**ARLINGTON COUNTY, VIRGINIA**

**County Board Agenda Item  
Meeting of February 6, 2025**

- A. GP-365-24-1 GENERAL LAND USE PLAN AMENDMENT to change the land use designation for the northeast portion of the block bounded by 23<sup>rd</sup> Street South, South Grant Street, South Hayes Street and 24<sup>th</sup> Street South, to include Parcel A (RPC #36-039-015) excluding Parcel B (RPC #36-039-016), which is and shall remain envisioned as a portion of Nelly Custis Park, from "Public" to "Low-Medium" Residential.

- C. SPLN24-00002 SITE PLAN (SP #478) to construct a 5-story mixed-use building with approximately 131,736 square feet (sf) of residential gross floor area (GFA) and 17,033 sf of institutional GFA, with modifications for additional density, reduced residential parking ratio, density exclusions, and other modifications necessary to achieve the proposed development, located at 750 23<sup>rd</sup> Street South (RPC# 36-039-015).

**Figure 30. Proposed 23<sup>rd</sup> Street South Cross Sections (Facing West).**

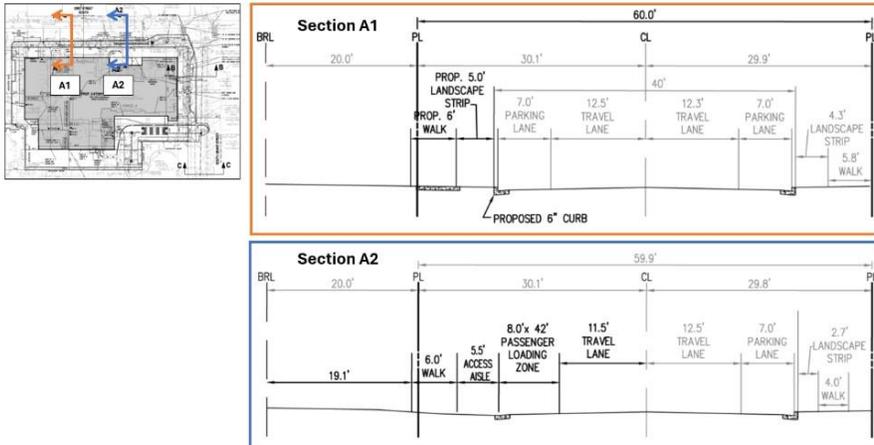
**Commented [sm71]:** 23<sup>rd</sup> Street has only 2 lanes. The smallest Type E

**Commented [sm72]:** Omitted: who decides this is necessary and why. Who requires it? Who pays for it? There are groups of day cares that cross this street daily to go to the park whose safety is being jeopardized.

**Figure 31. Proposed South Grant Street Cross Section (Facing North).**

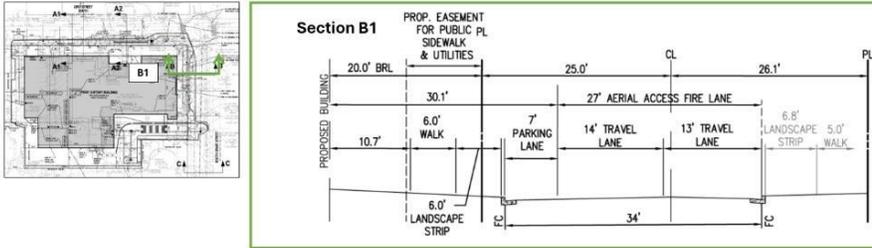
**Commented [sm73]:** There is no plan to replace this lost parking.

**Commented [sm74]:** Omitted: this will encourage speeding and is a safety hazard per PC Weir.
